Preliminary Design Consultation Responses to Comments and Recommendations

December 3, 2024

DSRFY2024-0018
Ozzy's Car Company
112 W. 42nd Street
Garden City, ID 83714

1 SITE PLAN

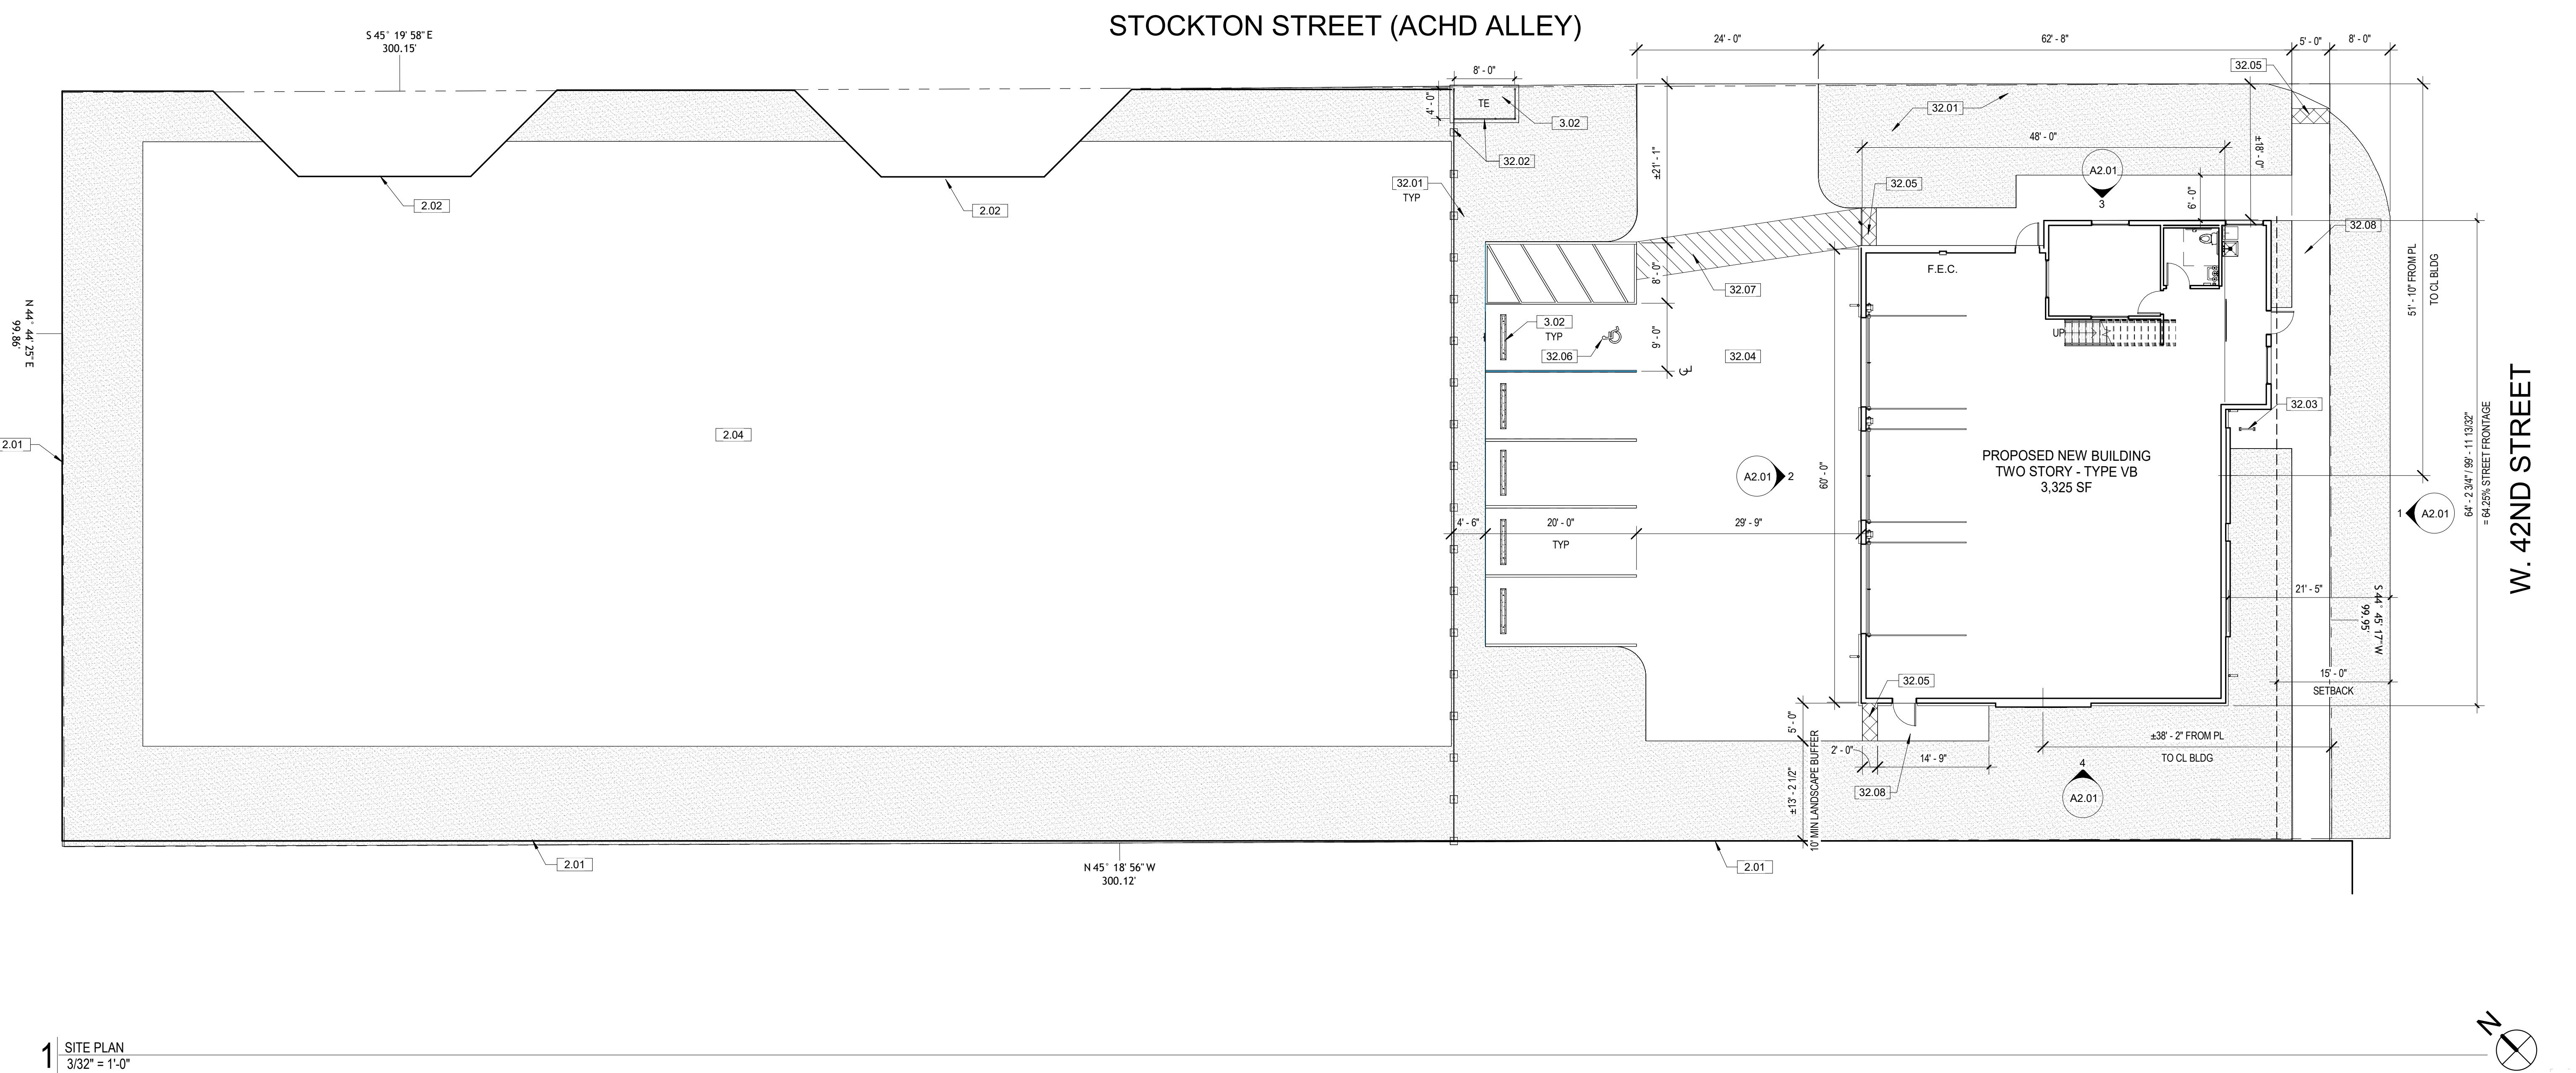
1. Parking lot location.
 - a. Proximity to intersection
 - b. Can't back up onto Stockton Street.

2. Chain link and barbed wire to be removed.
 - a. Compliant fencing on Stockton has height limit of 3.5'.

- 6. Landscaping of full perimeter if this is one lot.
 - a. Street trees on Stockton and 42nd.
 - b. Pedestrian focus on Stockton.
 - c. Terminal view at end of drive aisle.
 - d. 75% vegetative coverage.
 - e. Stockton curb not shown.

7. Trash enclosure or other solution.

The parking lot location is compliant with 8-4D Parking and Off Street Loading Provisions as noted in the Design Review Report and Decision dated October 21, 2024. The parking lot is designed where no vehicles are required to back up onto Stockton Street.

A portion of the existing chain link fencing will be removed to accommodate the new parking lot and landscaping for the building. The remainder of the existing chain link fencing will be replaced with new compliant fencing within two years of DR approval per CUPFY2022-0009 extension granted on July 22, 2024. New fencing for a small trash enclosure with alley service will be maximum 6 feet tall to sufficiently screen the carts per section 8-4C-4-F. Additional new fencing perpendicular to Stockton Street will be installed to secure the remainder of the lot.

Landscaping has been provided along full perimeter of the lot as required.

Refer to the updated Landscape Plan indicating grassy areas and landscaping along Stockton Street providing a pedestrian focus. A curb is not required on Stockton Street per ACHD approval GC22-0004/CUPFY2022-0009.

A small trash enclosure has been added at Stockton Street compliant with Republic Services' Solid Waste Design Standards for alley service.
